BRIEFING SUMMARY SHEET

DEVELOPMENT ASSESSMENT CASE NUMBER: CD-2020-0002 – Brodie Oaks Redevelopment

COMMENT REPORT

LAND USE AREA METRICS

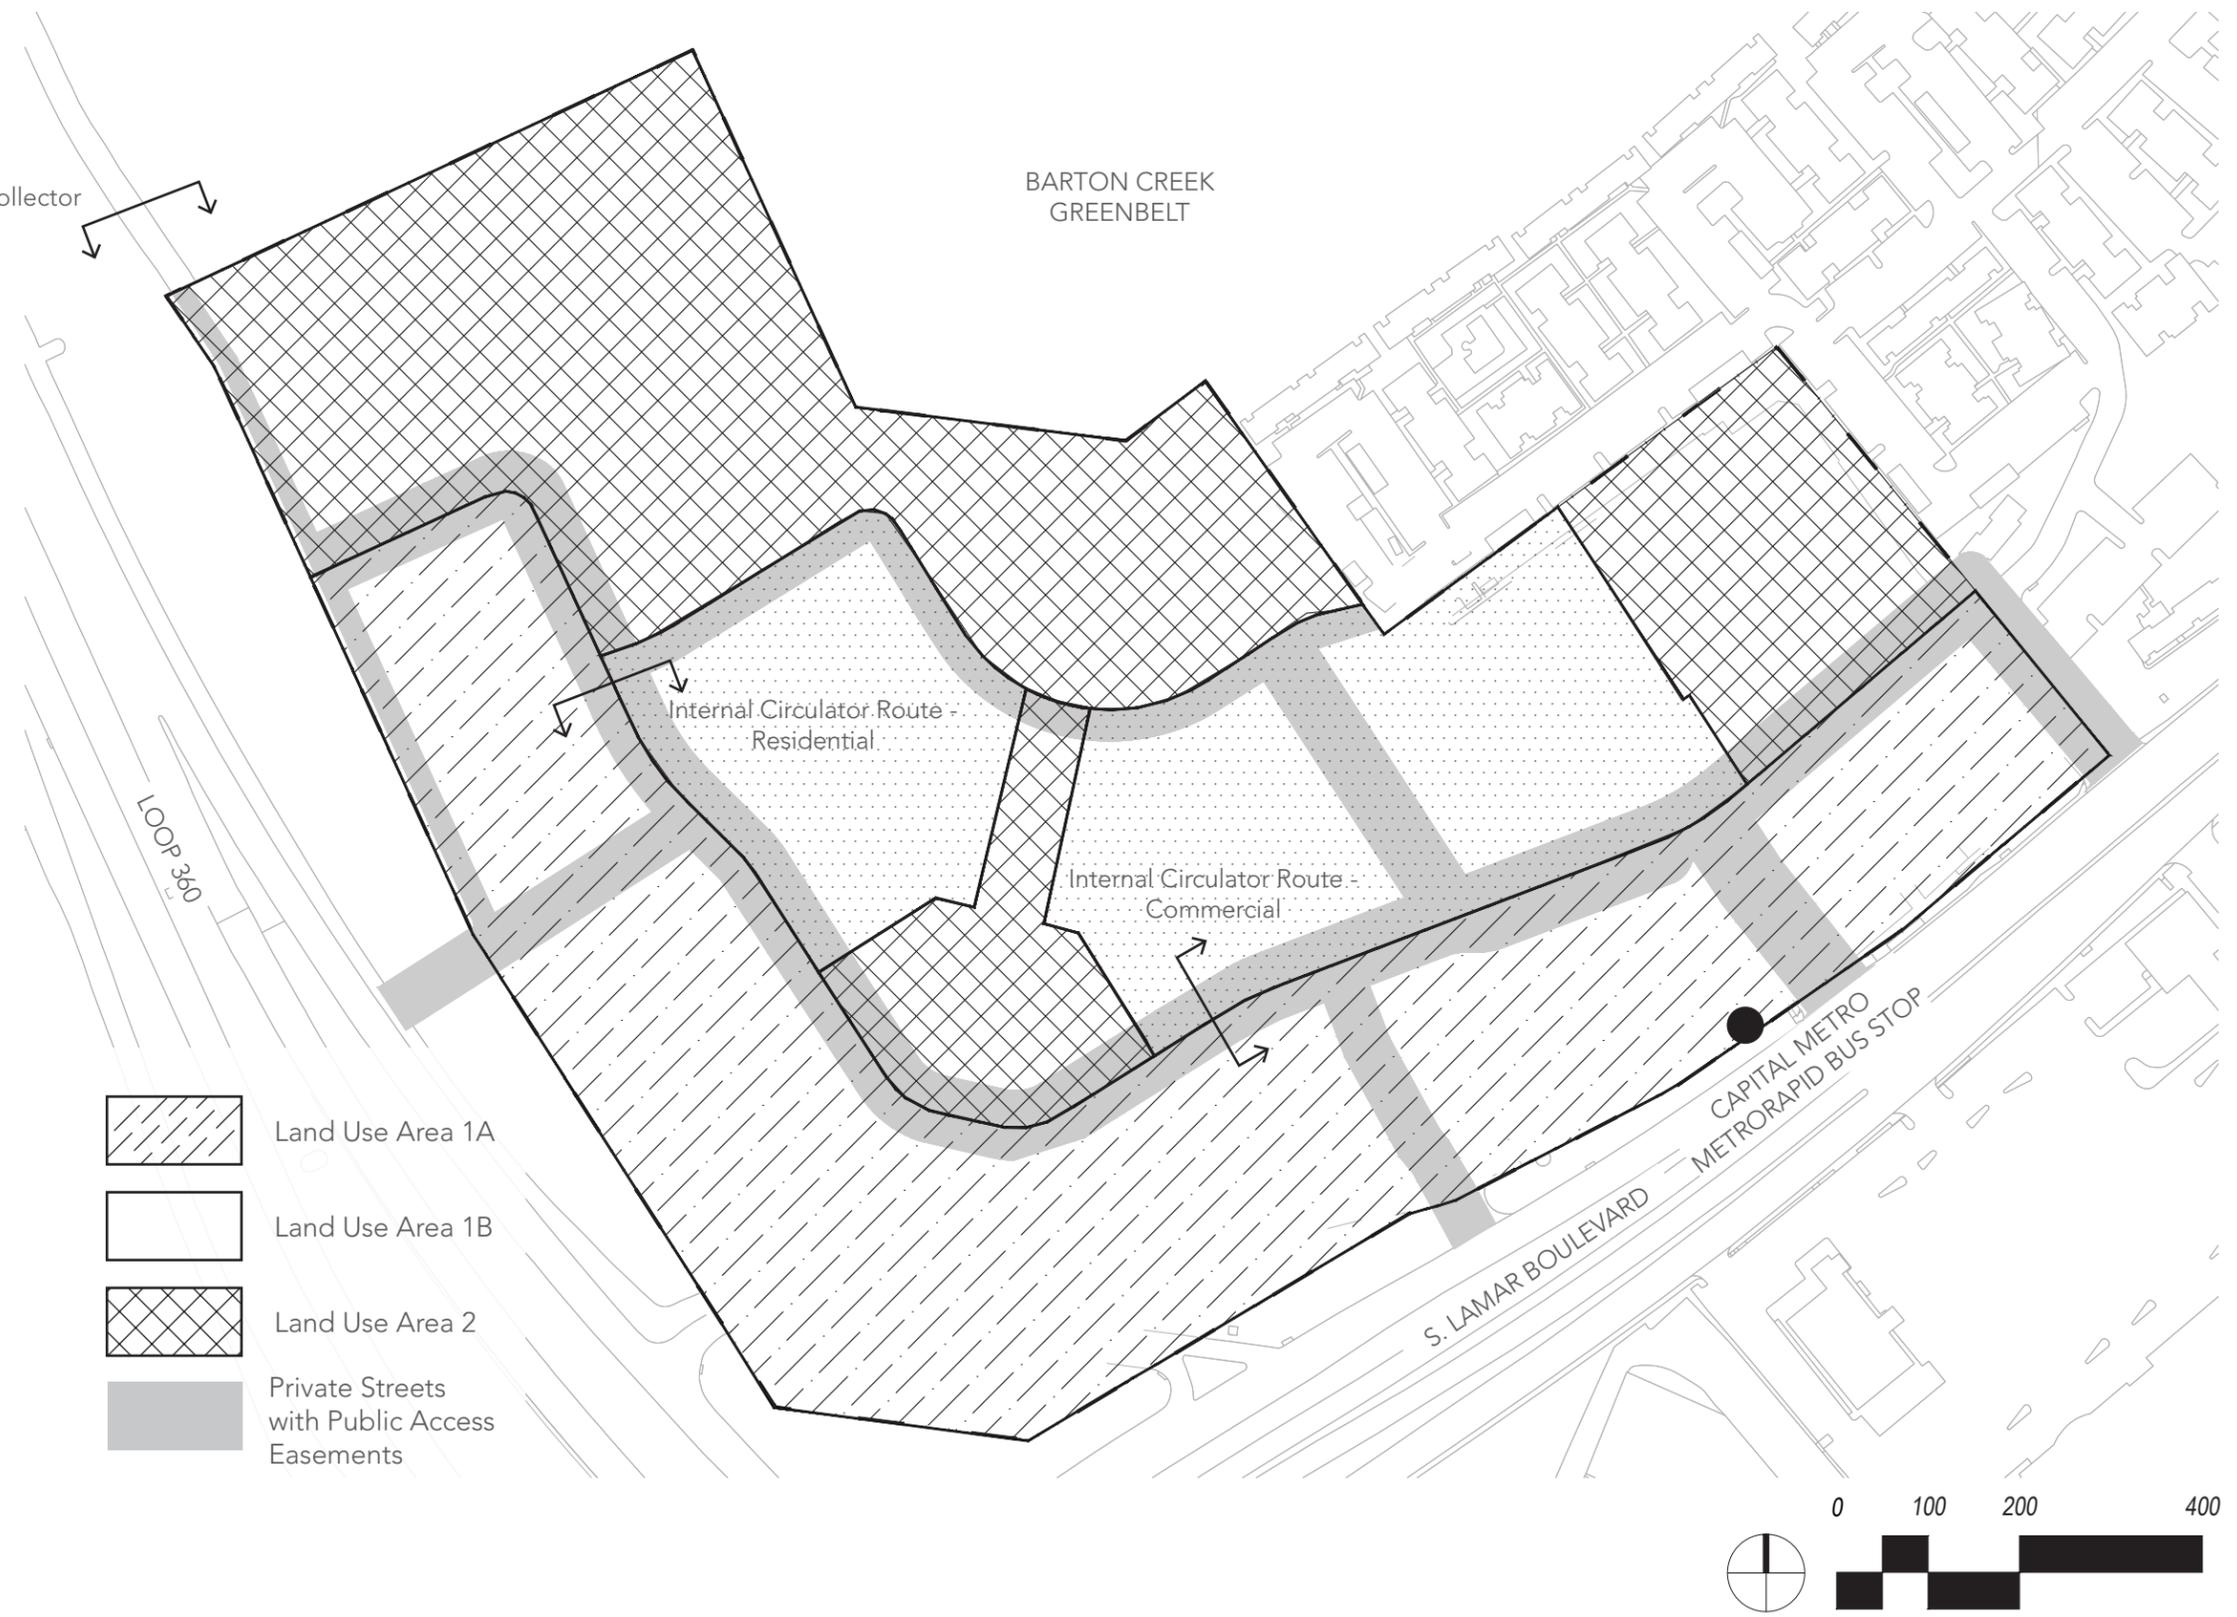
- EV16. Exhibit C: In alignment with comment EV 7, this comment is pending for Land Use Plan Note #2.
- EV17. Exhibit F: In alignment with comment EV 2, this comment is pending additional information to be provided as resolution for placement of the re-irrigation areas.

**BRODIE OAKS REDEVELOPMENT
GRADING PLAN**

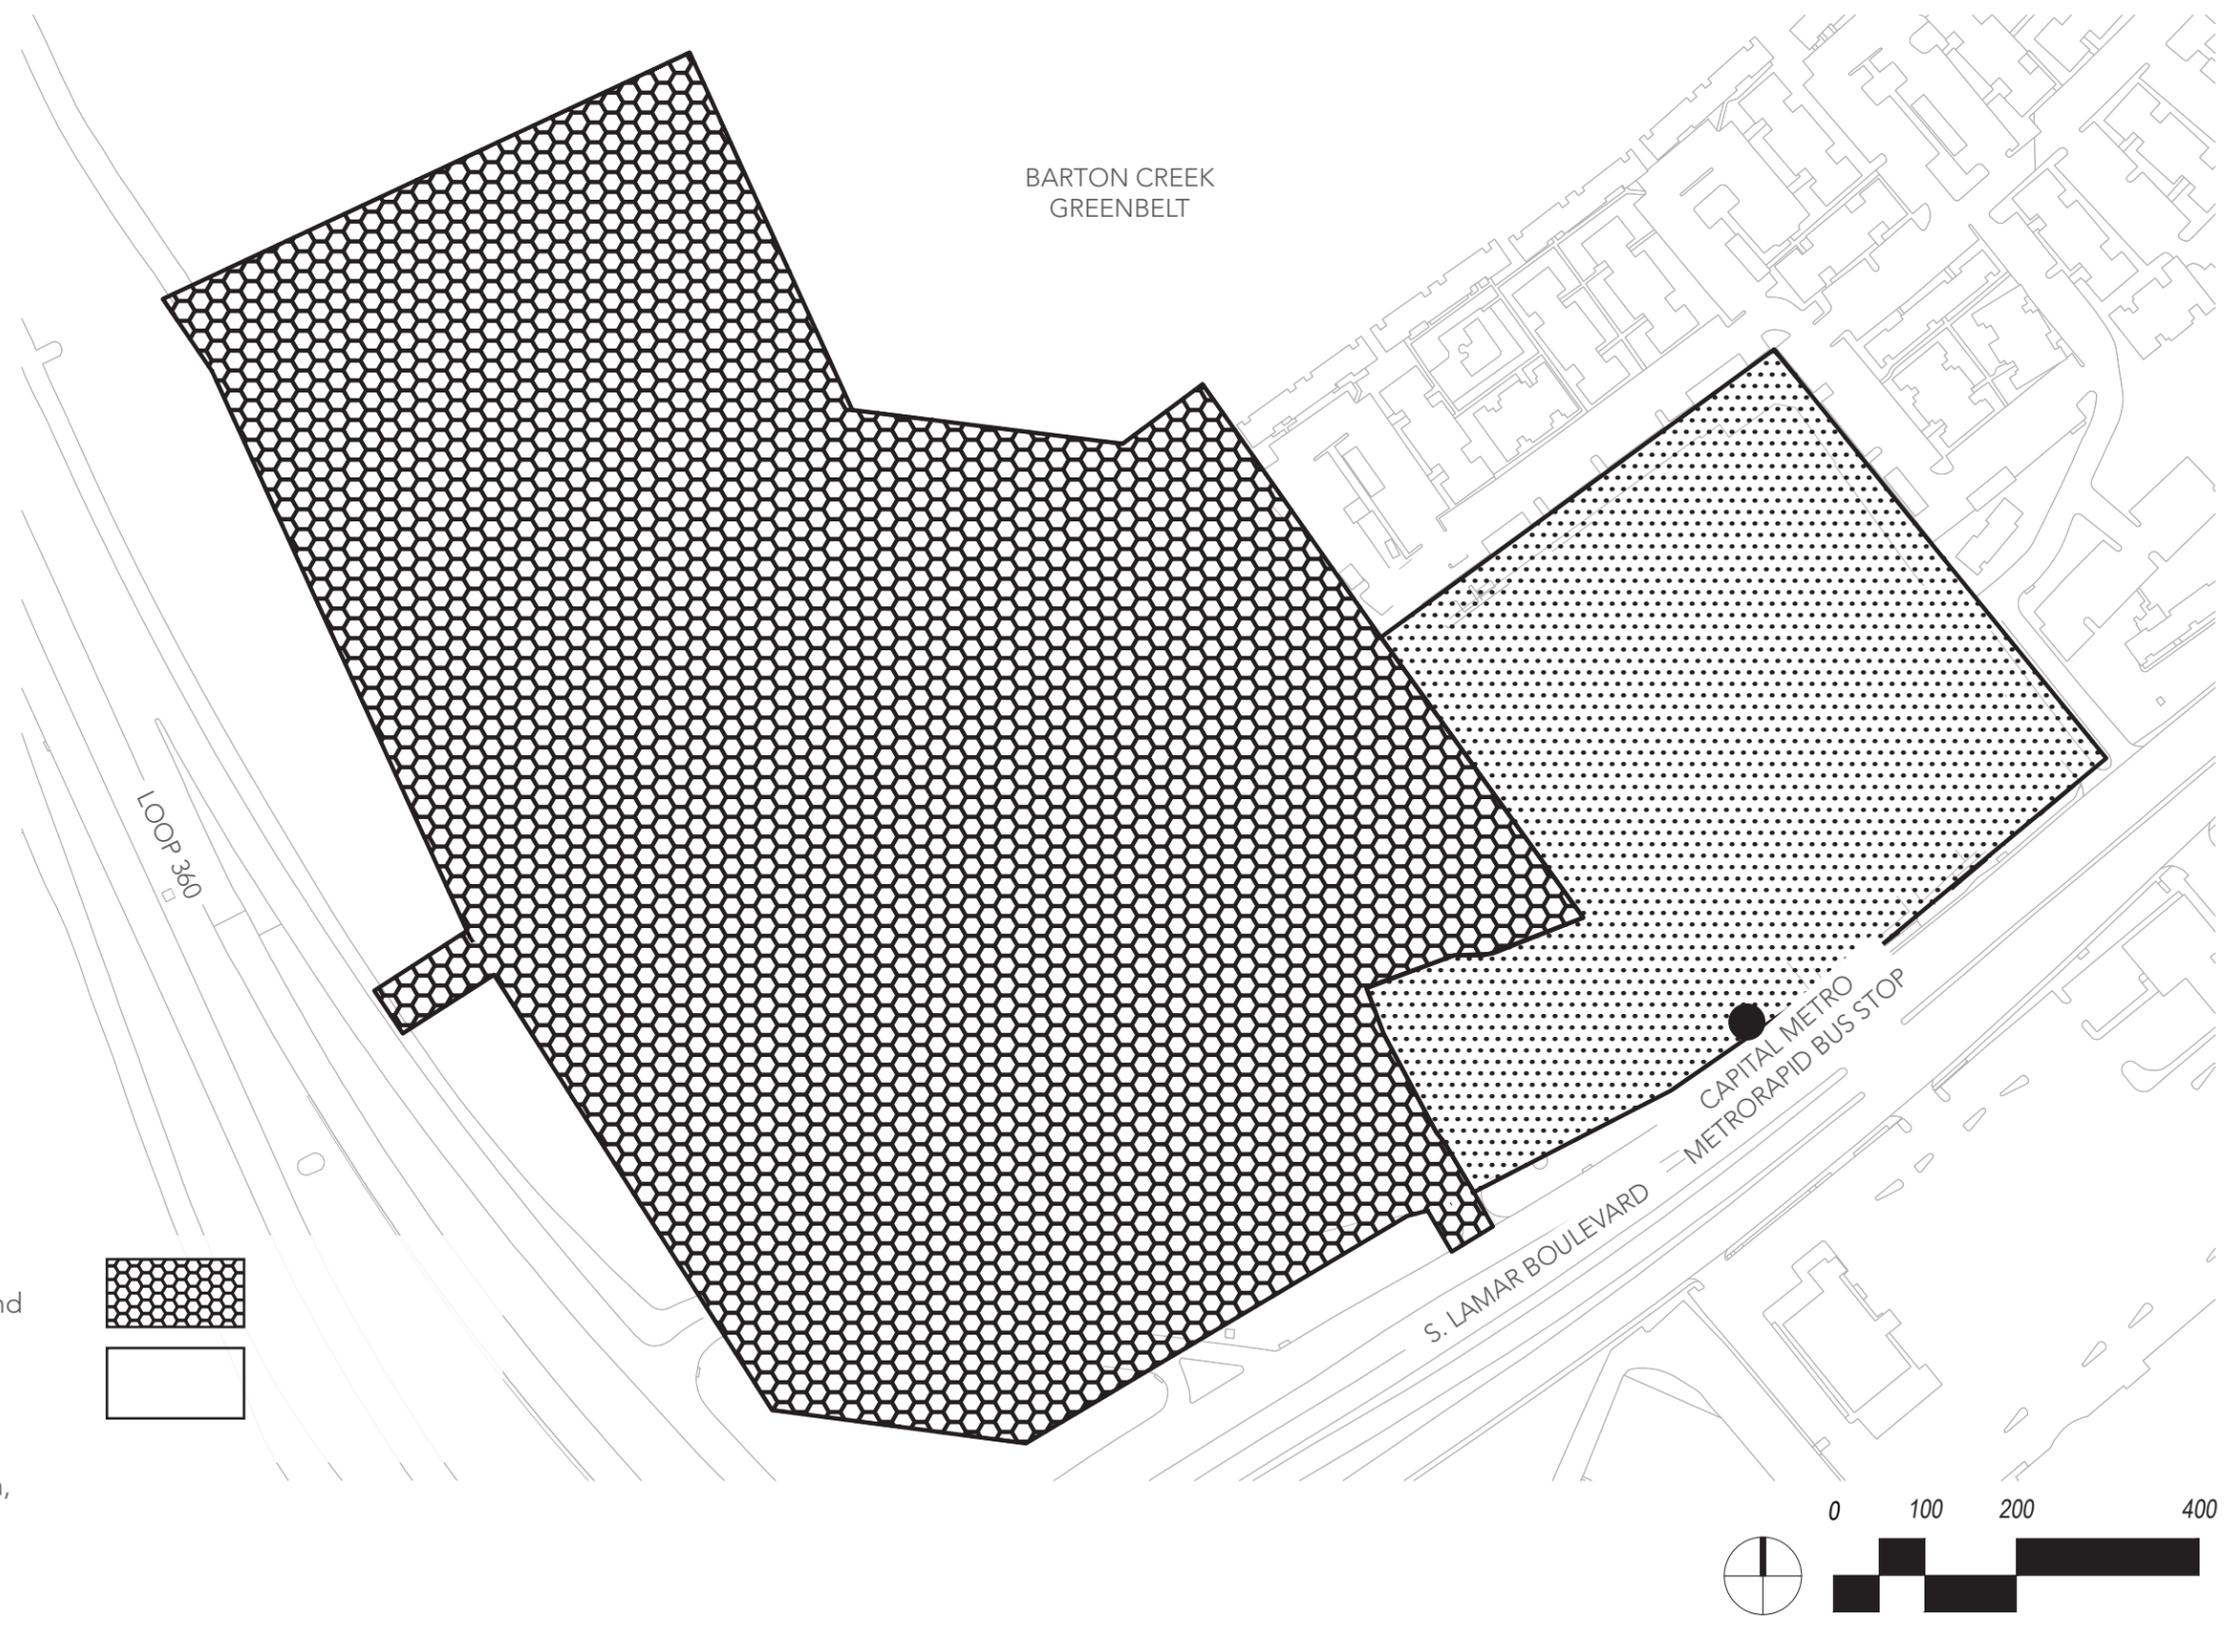
- CA 9. Exhibit G – Grading. For those areas of cut and fill proposed greater than four feet, please provide additional information and clarification on the overall disturbance of these requests and the trees potentially impacted in these areas. This request goes toward reviewing the PUD's overall tree preservation effort.
- CA 10. Trees proposed to be preserved must be shown with a continuous circle.

- EV18. Exhibit G: In alignment with comments EV 10 and EV 11, provide callouts or show more detailed information on the plan in order for Staff to fully determine if the proposed grading exceeding four feet in depth meets compliance with current code requirements and exceptions.

Figure 1. 1972 – cave passage survey

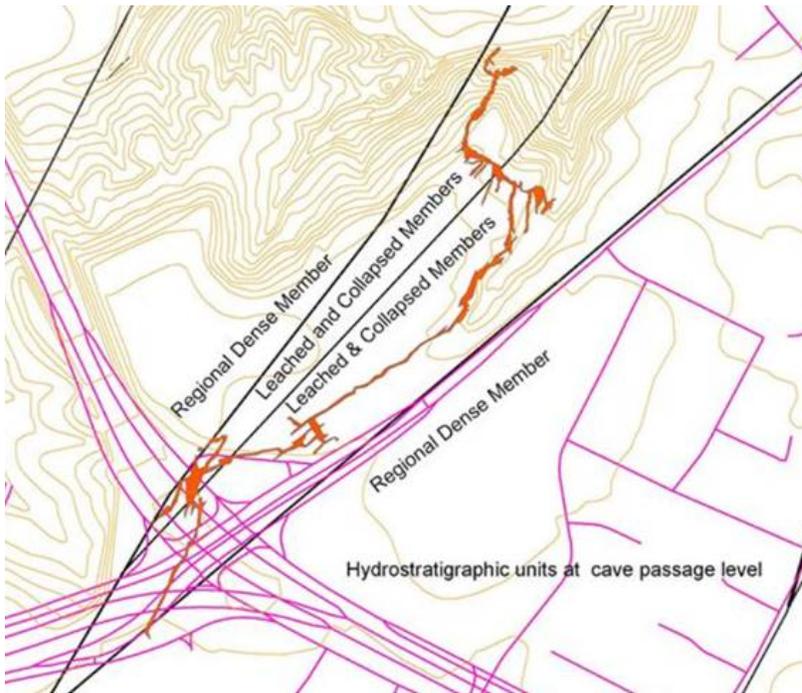
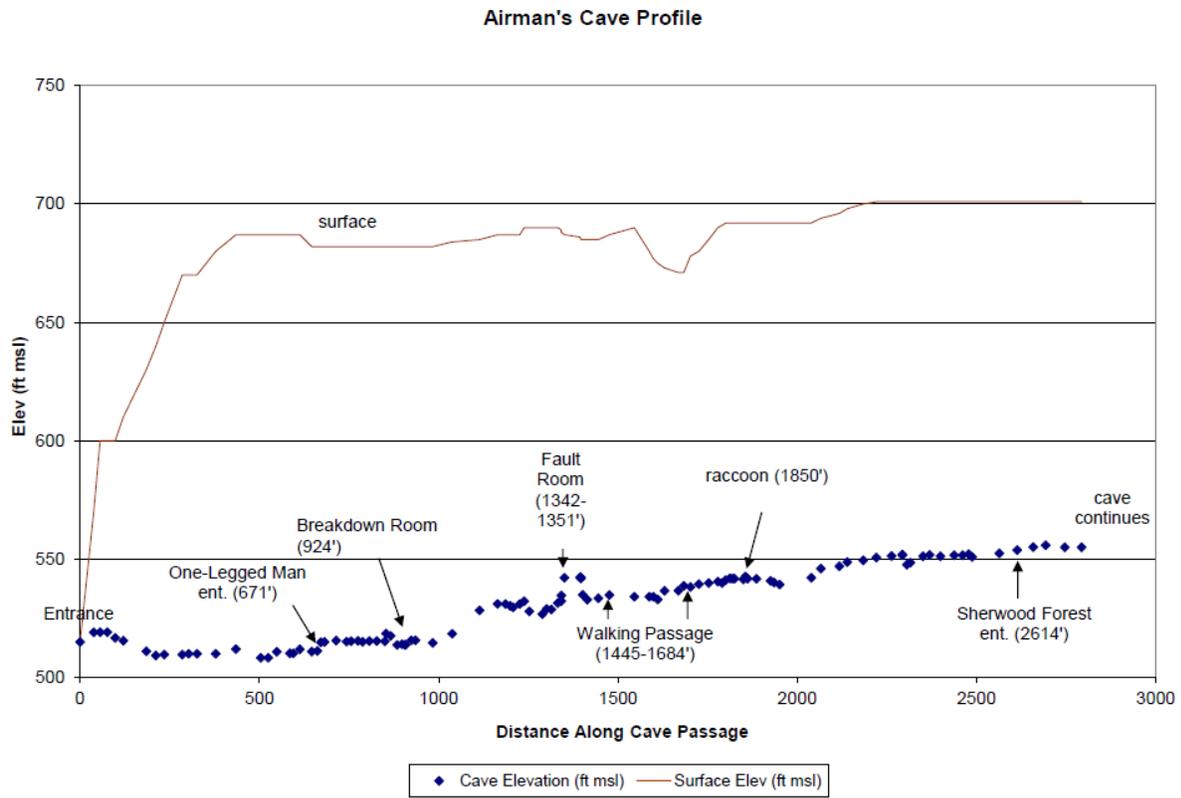
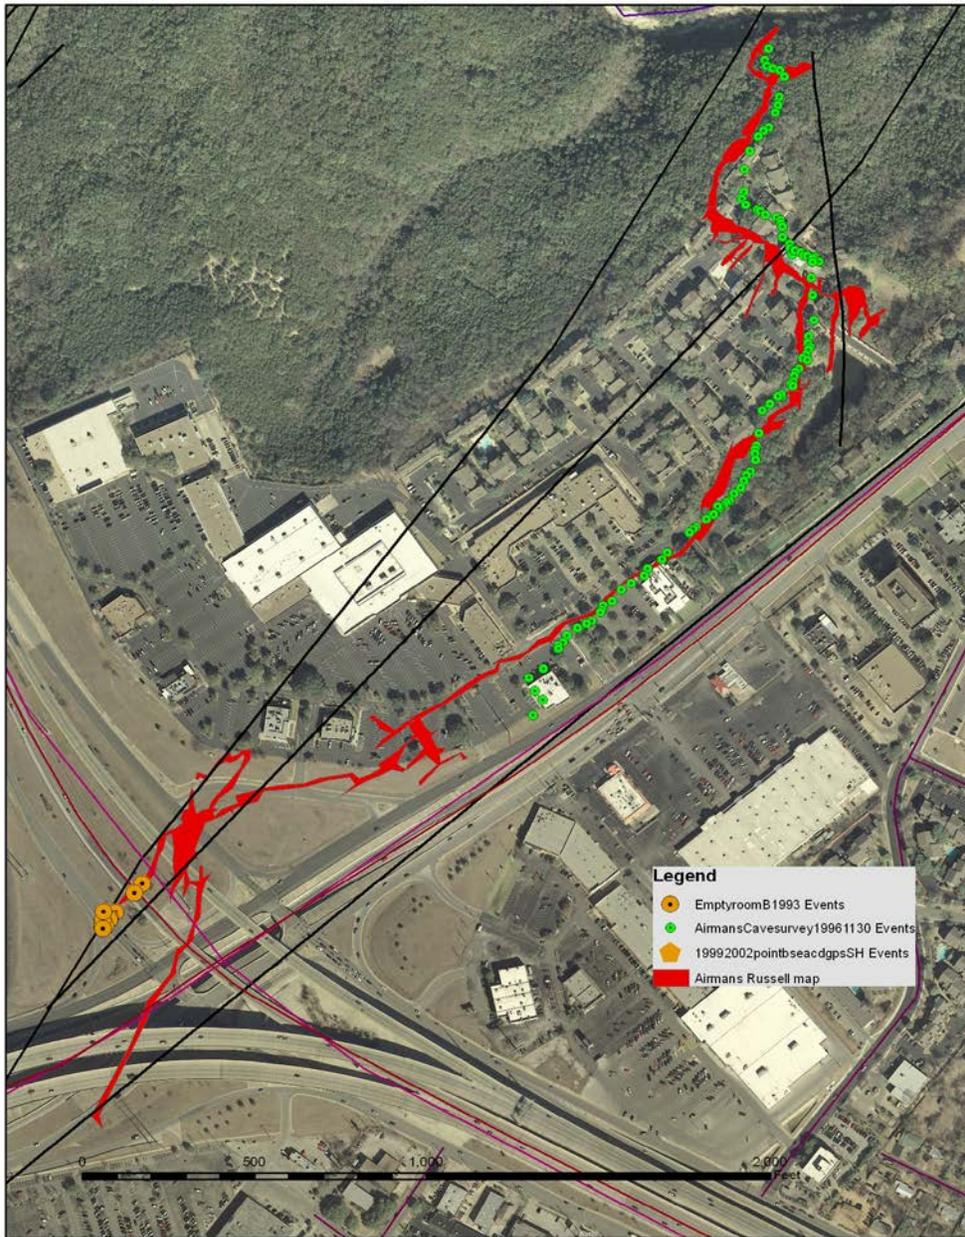
- HG 1. At this time, site specific information is unavailable or inaccurate regarding vegetation, areas of steep slope, or other environmental features such as bluffs, springs, canyon rimrock, caves, sinkholes, and wetlands. For example, the Environmental Resource Inventory Report prepared does not identify Airmans Cave, which is a cave listed on the City of Austin's 10A Permit. The cave passage is located beneath the site and is within 150-ft. The approximate location of cave passage is shown in map view below (Figure 1). Please be advised that according to Nico Hauwert, the 1972 survey map shown in red was not done with inclination measurements, so the actual horizontal distances are shorter than shown on the map, and one cannot determine rise in the cave passage from the entrance from the 1972 map. In 1995/1996, Mark Sanders, Jim Kennedy and Nico Hauwert remapped 2/3 of the Cave. The profile attached shows the cave depth relative to the surface for the first 2/3 of the cave were surveyed (Figure 2). The attached map compares their survey (green dots) to the red scan of the 1972 cave map (Figure 3). Please update the ERI report

to include Airmans Cave and any protective measures proposed to preserve the cave itself and the water quality and water quality in the cave.
